FINAL REPORT

Review of Ameren Missouri's 2011 Utility Resource Filing Pursuant to 4 CSR 240 – Chapter 22

(Case No. EO-2011-0271)

For the Missouri Department of Natural Resources

Figure 3-5: Residential Summer Peak Demand by Region and End-Use

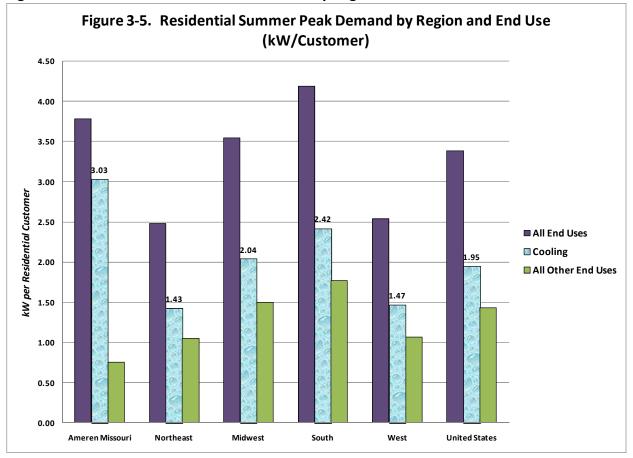
Ameren Missouri had 1,027,660 residential customers in 2010.¹⁸ Dividing the hypothesized residential cooling load in that year by the number of customers yields a coincident peak demand of 3.03 kW per customer. This estimate of peak demand for cooling is significantly higher than other available estimates. Figure 3-5 compares Ameren Missouri's estimates with those reported in a recent Electric Power Research Institute (EPRI) report.¹⁹ The chart breaks residential demand at the time of the summer peak into cooling and all other end-use components.

The EPRI estimates for different regions of the U.S. are for the year 2008 while the Ameren Missouri estimates are for 2010. EPRI's kW per customer cooling demand estimate for the Midwest region is 2.04 kW compared to Ameren Missouri's 3.03 kW. This suggests that Ameren Missouri's kW per customer estimate may be overstated by as much as 33%, or by roughly 1,019 MW in 2010. As a counterpoint to this, the peak demand associated with other residential end-uses would appear to be understated.

- (a) In the interim period prior to its next regularly scheduled compliance filing, Ameren Missouri should clarify the extent to which its DSM analysis is affected by its assumptions related to residential and commercial end-use contributions to peak load. If the demand-side resource analysis is sensitive to these assumptions, Ameren Missouri should consider conducting a load research study related to residential air conditioning use in its service territory. This study would provide an empirical basis for its cooling load shape assumptions.

Figure 3-6: End-Use Contributions to Commercial Peak Demand

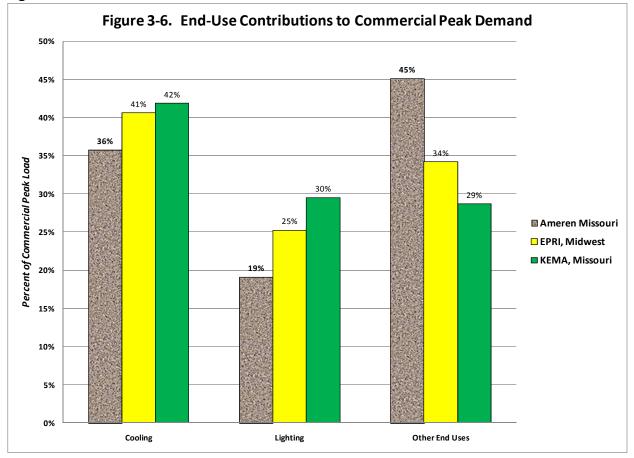
Ameren Missouri's allocation of its commercial end-use load to summer peak is also suspect. The Company estimates that 36% of its commercial load at the time of the 2010 summer peak was cooling and that 19% was associated with lighting. Figure 3-6 compares Ameren Missouri's estimates with those reported in the above referenced EPRI report and with KEMA's estimate for the State of Missouri. The chart breaks commercial demand at the time of the summer peak into cooling, lighting and all other end-use components. Ameren Missouri's allocation of its commercial load to cooling and lighting is less than what would be expected based upon the EPRI and KEMA studies. This raises a concern that Ameren Missouri's demand-side resource analysis may undervalue cooling and lighting efficiency measures, because it has underestimated their contribution to peak load.

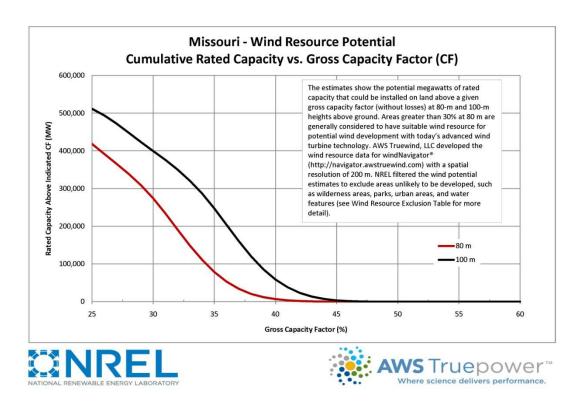
(1) Ameren Missouri did not consider the capacity factors for the *best* commercially available wind sites, but used an average of capacity factors across several Midwest states.²⁸

In its response to DR1, Ameren explained that "For resource planning purposes Ameren Missouri characterized a generic wind resource in the Midwest (North Dakota, South Dakota, Nebraska, Kansas, Oklahoma, Minnesota, Iowa, Missouri, Wisconsin, Illinois, and Indiana). A capacity factor of 37.5% was estimated using the latest wind potential estimates from the National Renewable Energy Laboratory (NREL) for the Midwest at an 80 meter hub height." Clearly Ameren did not isolate on specific multi-county regions, though one could argue that multi-state regions include multi-county regions. However, it is clear that the capacity factor of an *average* wind resource was considered, rather than the *best* wind resource at *commercially available wind sites*.

Ameren did provide the analysis for two locations (Callaway and Coffeen) that was supported by 3Tier's First Look wind analysis product. These analysis were for specific locations (latitude and longitude to three decimal places), rather than a multi-county area. Further, the analyses showed capacity factors of 20 to 23 percent for a generic wind turbine at 80 meters, illustrating that the analyses were not representative of the IRP.

Figure 6-1: CHP Technical Potential From DG Market Penetration Assessment⁶⁹

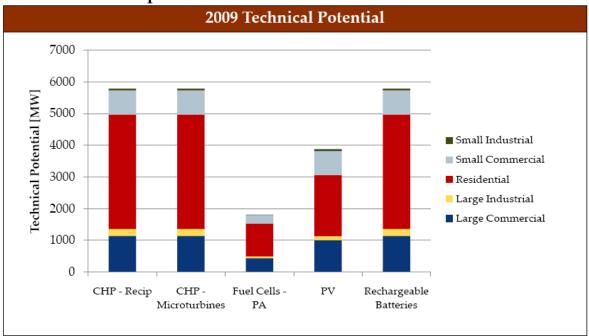
In spite of this finding, Ameren Missouri states in the IRP that, "PV provides the best opportunities in the current operating environment and has therefore received a majority of the resources thus far." Explaining this focus on PV in their response to DNR 0107, Ameren Missouri states that, "distributed solar photovoltaics represent an opportunity for Ameren Missouri to comply with renewable energy standard (RES) requirements. While CHP does have favorable economics, their generation technologies have significantly more emissions and the utility cannot utilize any CHP to count towards meeting the RES requirements." It does not follow that because one DG technology, PV, helps Ameren Missouri comply with RES requirements that it should therefore eliminate another DG technology, CHP, from potential inclusion in its portfolio of DSM programs, especially if, as the utility states, CHP has favorable economics and the most promising future. The following chart from the Ameren Missouri's DG Market Penetration Assessment shows that CHP has significant market potential.

CHP and batteries have the highest technical potential because they are sized to meet peak load.

Within 120 days following the Commission approval of agreement on this remedy, Ameren Missouri should provide a detailed analysis to support the elimination of CHP as a primary DG resource option that at a minimum considers all of the potential benefits identified by the Combined Heat & Power Partnership of the U.S. Environmental Protection Agency (See above discussion).
